## **System Impact Assessment Addendum - Underwood Wind Generating Station (WGS) Connection Assessment & Approval Process**

**Issue 2.0**

**CAA ID 2004-143**

<b>Document ID</b>	IESO_REP_0327
<b>Document Name</b>	System Impact Assessment Addendum
<b>Issue</b>	Issue 2.0
<b>Reason for Issue</b>	Addendum to SIA report dated December 5, 2006
<b>Effective Date</b>	February 12, 2010

**Underwood Wind Generation Station**  
**199.65 MW (B4V - 99 MW/B5V - 100.65 MW)**

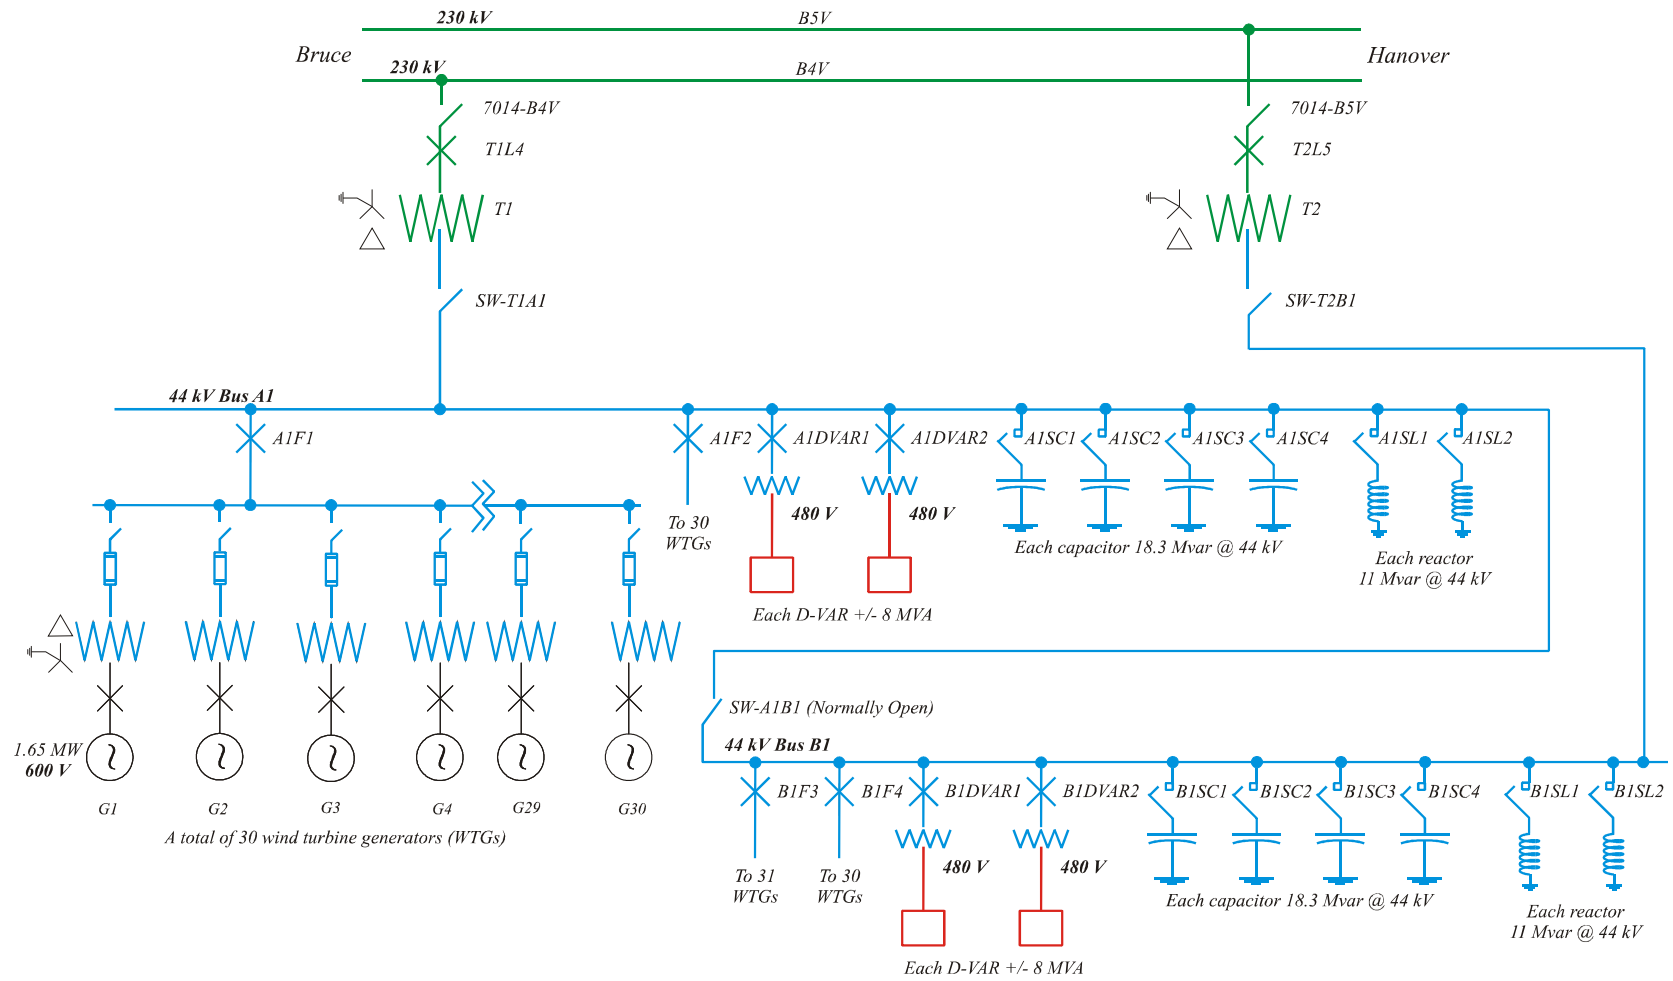
Special protection system facilities must be installed at Underwood to accept a single pair (A & B) of G/R signals from the BSPS, and disconnect from B4V and B5V with no intentional time delay, when selected for pre-arming by the IESO. These special protection system facilities must also comply with the NPCC Criteria Document A-11 for Type 1 special protection systems. Enbridge must provide two dedicated communication channels, separated physically and geographically diverse, between Underwood and the Bruce NGS.

The following actions should be taken to disconnect Underwood facility from B4V and B5V upon receipt of generation rejection signals from the BSPS.

Trip all 44 kV breakers and capacitor/reactor circuit switchers and if any 44 kV breaker/circuit switcher on A1 bus and B1 bus fail to operate, breaker-failure is to initiate tripping of the 230 kV breakers, T1L4 and T2L5, respectively. Further tripping (i.e. of 230 kV breakers on the B4V and B5V circuits at Bruce TS, Orangeville TS and Hanover TS) must not be initiated should any of the 230 kV breakers T1L4 or T2L5 fail to operate.

After being tripped by the BSPS, the closing of the breakers is not permitted until approval is obtained from the IESO.

Enbridge is required to work with Hydro One to design and jointly implement the scheme. It is required that the BSPS changes and the registration of the changes through the Markey Entry process be completed by April 30, 2010.
